**Comment Summary – November 21, 2024 (4<sup>th</sup> Submission)**  
**Zoning By-law Amendment Application – WDD Main St. Inc.**

**Re: Zoning By-Law Amendment 4th Submission  
11 Main Street (Morrison)  
Puslinch, ON**

**RE:** Hydrogeological Review Comments – 4<sup>th</sup> Submission  
WDD Main Street Inc. – 11 Main Street, Morriston (Puslinch), Ontario  
Proposed Residential Subdivision  
Zoning By-law Amendment / Draft Plan of Subdivision Application

Design	M.I.M.	Project No.	<b>2366-6537</b>
Check	B.W.	Scale	1:500
		Dwg.	<b>FIG. 3</b>

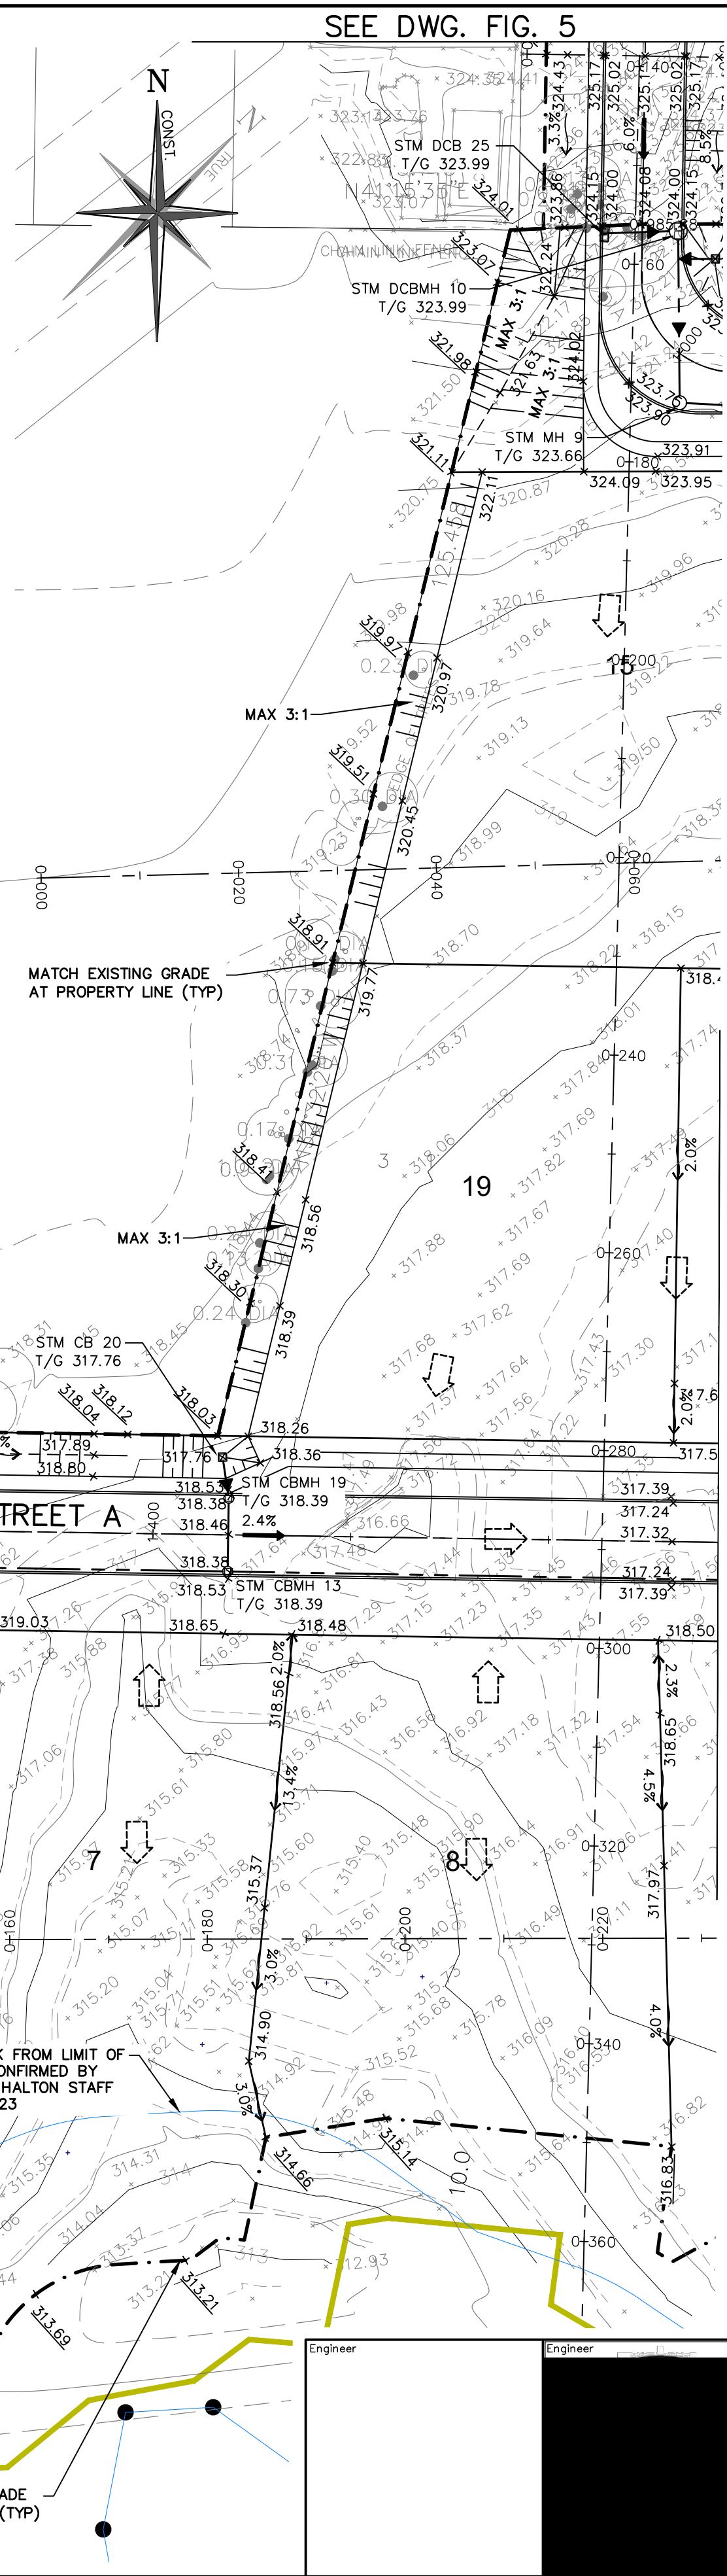
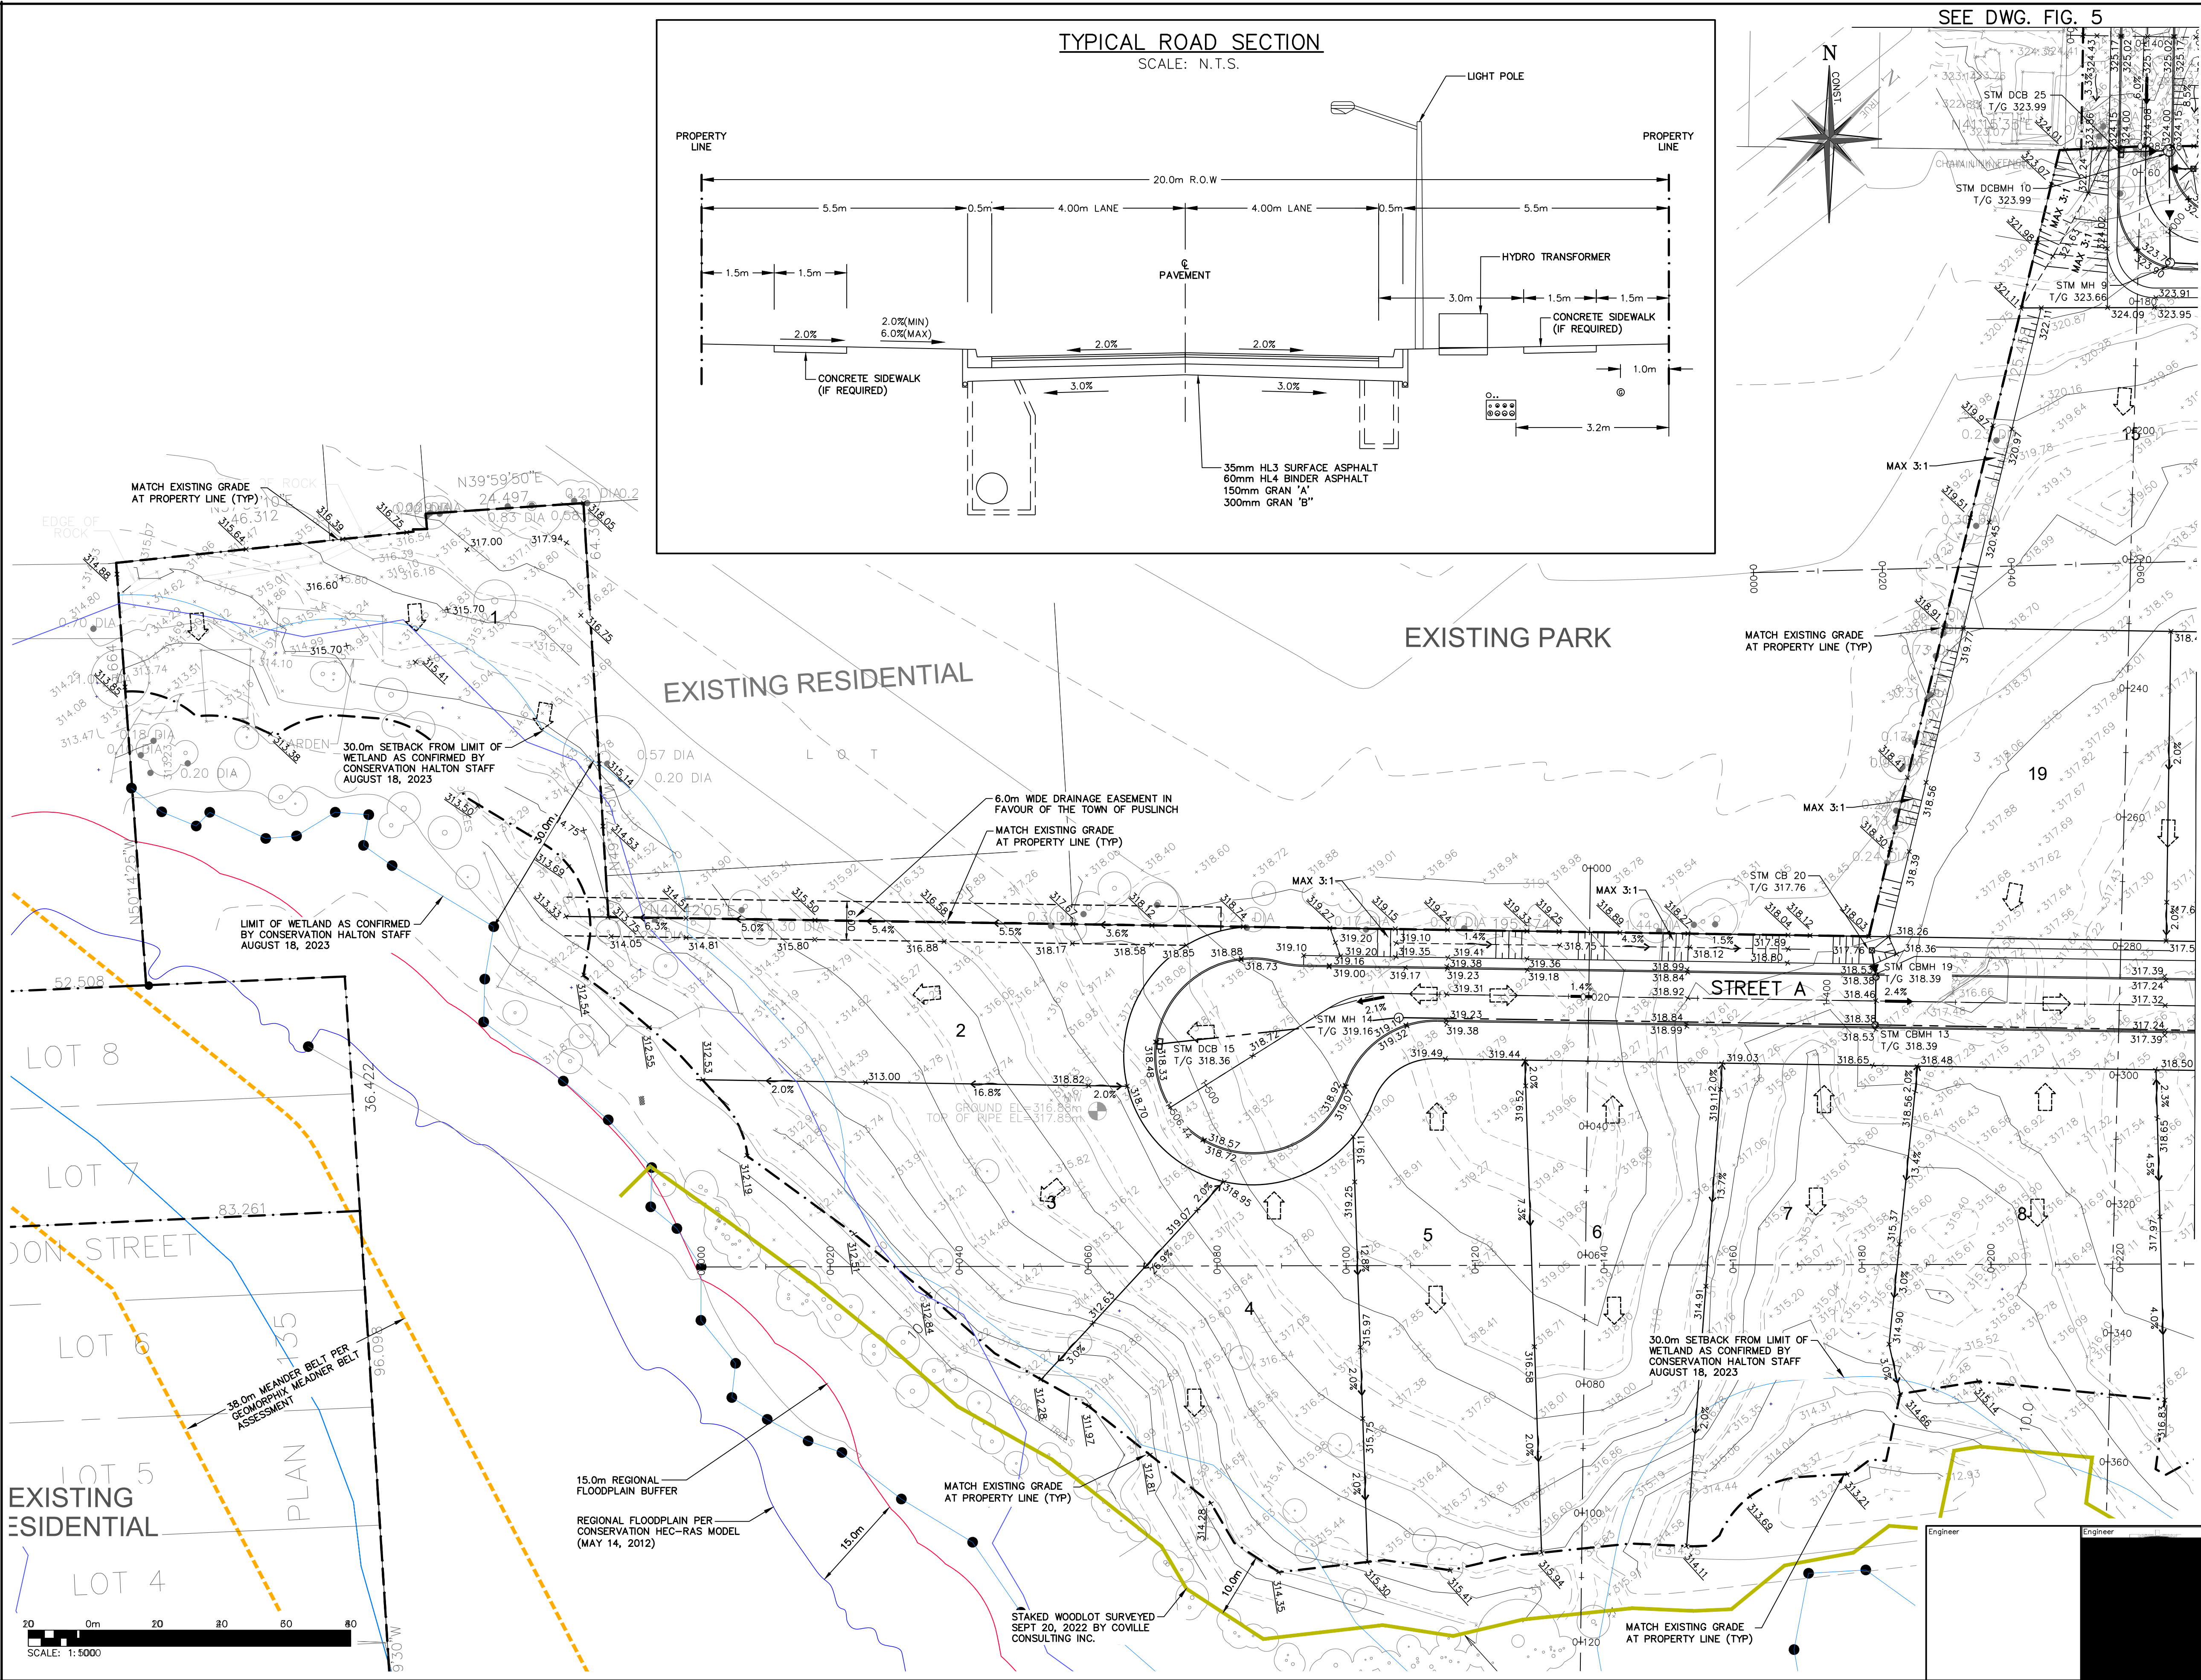
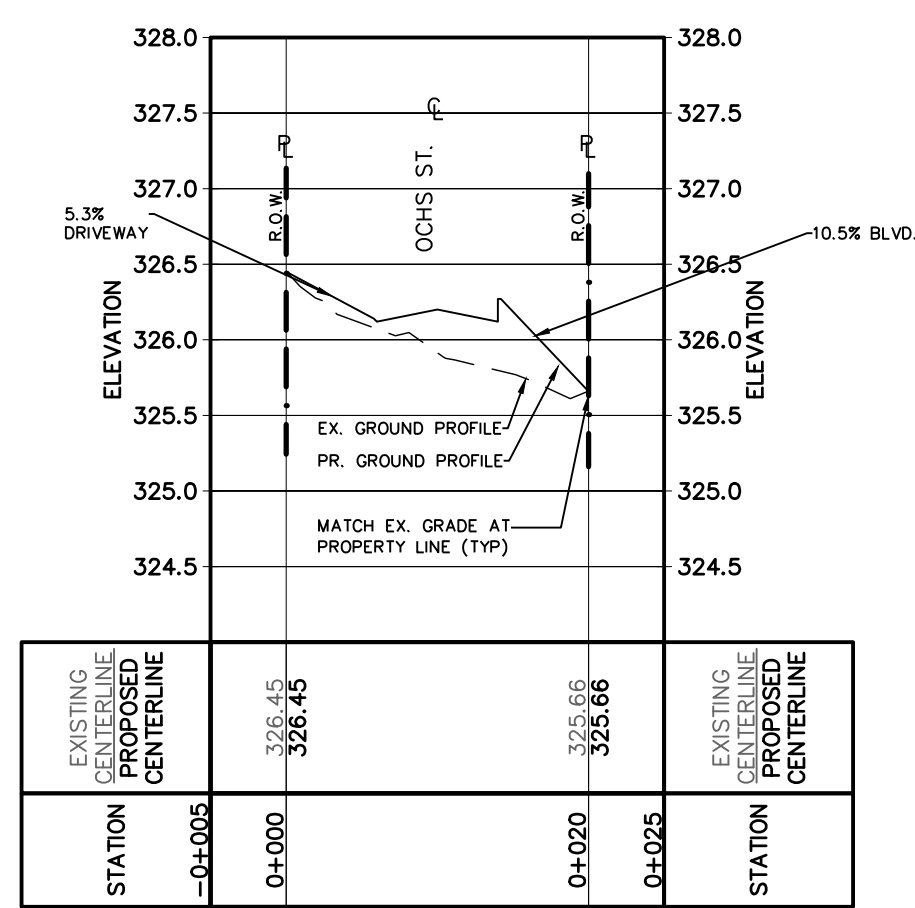
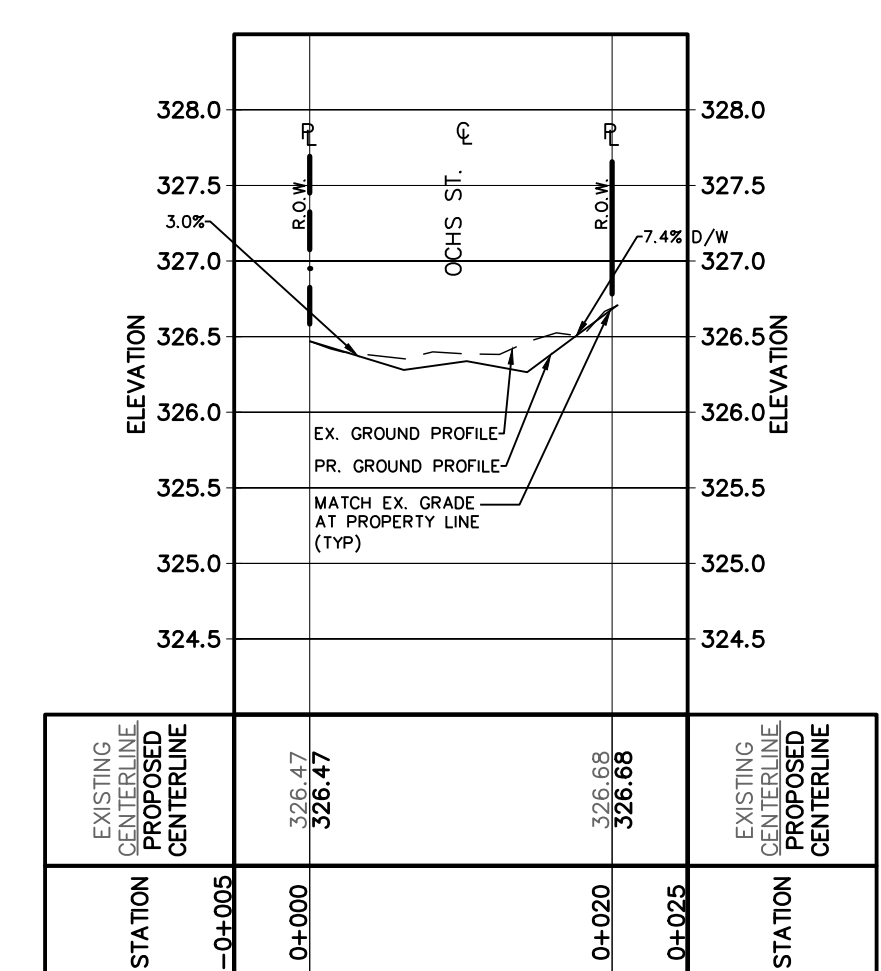
17.	Ponding at Catchbasin	Engineering Plans	February 9, 2024, September 27, 2024	<p><u>GEI Comment (February 9, 2024)</u>            The Site Grading Plan shows that proposed catchbasin CB 36 has a T/G elevation of 316.89, which is 1.5m lower than the adjacent curb elevation proposed. Considering the proximity of CB 36 to the property line, there is concern that stormwater will pond onto the neighbouring property at catchment EX2.            Please show that the storm sewer leaving CB 36 will have the capacity to convey the flow generated by EX2 with ponding contained to the subject property up to and including the 100yr storm event. Additional topographic survey may be required on the adjacent lands.</p> <p><u>Crozier Response (September 2024)</u>            CB 27 (formerly CB 36) and the receiving storm sewer system have been designed to convey the 100-year storm event. The sizing was complete utilizing Visual Otthymo and Flowmaster. Further details will be provided at detailed design.</p> <p><u>GEI Comment (September 2024)</u>            Per Puslinch development standards, storm sewers are to be designed using the rational method and a <b>storm sewer design sheet</b> is to be provided to demonstrate that the 100-year storm can be conveyed. The first reach of the storm sewer in the cul-de-sac bulb should have a slope of</p>

No.	Matter	Document	Date Identified	Comment
				<p>at least 1%, currently it is shown as 0.5%. All other storm sewer should have a slope of at least 0.5%.</p> <p>As discussed with Crozier staff, additional topographic data may be required to show the 100-year storm event ponding limits at detailed design.</p> <p><u>Crozier Response (November 2024)</u>            Sewers have been designed to convey the minor system (5-year event). Major storms are proposed to be conveyed via overland flow within the right-of-way and will spill into the pond at low point in the development.</p> <p>The first reach of storm sewer in the cul-de-sac bulb has been adjusted to 1%.</p> <p><u>GEI Comment (December 13, 2024)</u>            We note that one stretch of storm sewer (CBMH 11 – DCBMH 12) has a slope of 0.4%, which is lower than Township standards, however the flow velocity is within the allowable range per Township Standards.</p> <p>No further comment.</p>
